# Access Compliance Report

## Public Rights-of-Way

### (Curb Ramps)

Intersection ID: 50226	Main Street: S_TRYON_ST	Cross Street: TAMARACK_DR	Location: NW
ADA ID: 683B5B0768A7	Ramp Type: PerpDiag	Initial Pass/Fail: Fail	Overall Compliance: No
		Severity Score: 33.75

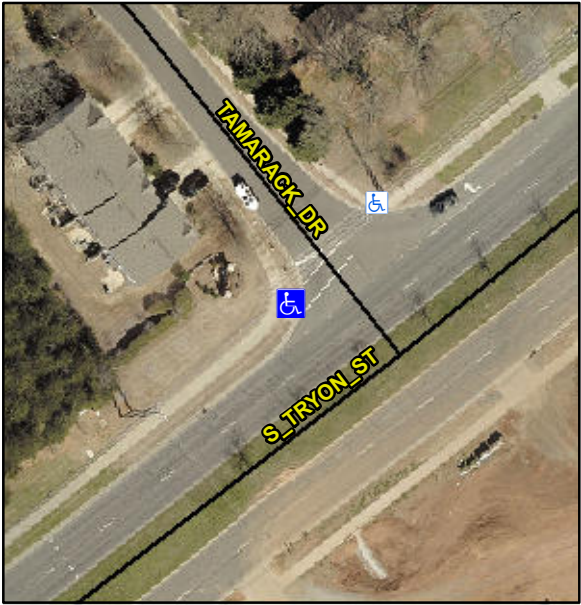
Codes/Mitigation Info/Possible Solution		Field Measurements/Component Compliance			
 <p>Street 1 Name                      <b>S TRYON ST</b></p> <p>Stop Condition-Street 2                      <b>None</b></p> <p>Street 2 Name                      <b>TAMARACK DR</b></p> <p>Stop Condition-Street 1                      <b>StopSign</b></p>	Possible Solutions:	<b>Remove &amp; Replace Curb Ramp With Two New Directional Ramps or Equivalent.</b>			
	Surveyor Notes:	<b>N/A</b>			
	PROW/ADA:	<b>Not Found, R304.5.1, R304.5.3</b>			
	Total Cost:	<b>\$ 3200.00</b>			
			<b>Compliance</b>	<b>Description</b>	<b>Data</b>
			<b>Yes</b>	<b>Ramp Slope (%)</b>	<b>7.2</b>
			<b>No</b>	<b>Ramp XSlope (%)</b>	<b>7.1</b>
			<b>N/A</b>	<b>Flare Type LT</b>	<b>N/A</b>
			<b>N/A</b>	<b>Flare Slope LT (%)</b>	<b>N/A</b>
			<b>N/A</b>	<b>Flare Traversable LT?</b>	<b>N/A</b>
			<b>N/A</b>	<b>Landing Length (in)</b>	<b>N/A</b>
			<b>N/A</b>	<b>Landing Width (in)</b>	<b>N/A</b>

<b>N/A</b>	<b>Landing Slope (%)</b>	<b>N/A</b>
			<b>N/A</b>	<b>Landing X Slope (%)</b>	<b>N/A</b>
			<b>N/A</b>	<b>Landing Curb? (Y/N)</b>	<b>N/A</b>
			<b>N/A</b>	<b>Shared Landing?</b>	<b>N/A</b>
			<b>N/A</b>	<b>Gutter Ponding?</b>	<b>N/A</b>
			<b>N/A</b>	<b>Gutter Lip Ht (in)</b>	<b>N/A</b>
			<b>No</b>	<b>Painted X Walk1?</b>	<b>Yes</b>
			<b>To SE</b>	<b>X Walk 2 Direction</b>	<b>To NE</b>
			<b>N/A</b>	<b>X Walk 1 Width (in)</b>	<b>104.0</b>
			<b>3.4</b>	<b>X Walk 2 Slope (%)</b>	<b>3.9</b>
			<b>4.1</b>	<b>X Walk 2 X Slope (%)</b>	<b>3.0</b>
			<b>N/A</b>	<b>Ramp inside XWalk1?</b>	<b>Yes</b>
			<b>6.7</b>	<b>Ramp inside XWalk2?</b>	<b>Yes</b>
			<b>0.9</b>	<b>Road Slope (%)</b>	<b>N/A</b>
			<b>N/A</b>	<b>Clear Space?</b>	<b>N/A</b>
			<b>N/A</b>	<b>Road X Slope (%)</b>	<b>N/A</b>
			<b>N/A</b>	<b>Clear Space to XWalk (in)</b>	<b>N/A</b>
			<b>N/A</b>	<b>Any Obstructions?</b>	<b>N/A</b>
			<b>N/A</b>	<b>Obstruction Type</b>	<b>N/A</b>

<b>N/A</b>	<b>Storm Grate/Utility Hazard?</b>	<b>N/A</b>
			<b>N/A</b>	<b>Storm Grate/Utility Type</b>	<b>N/A</b>
			<b>Yes</b>	<b>Surface Condition? (G/P)</b>	<b>Good</b>
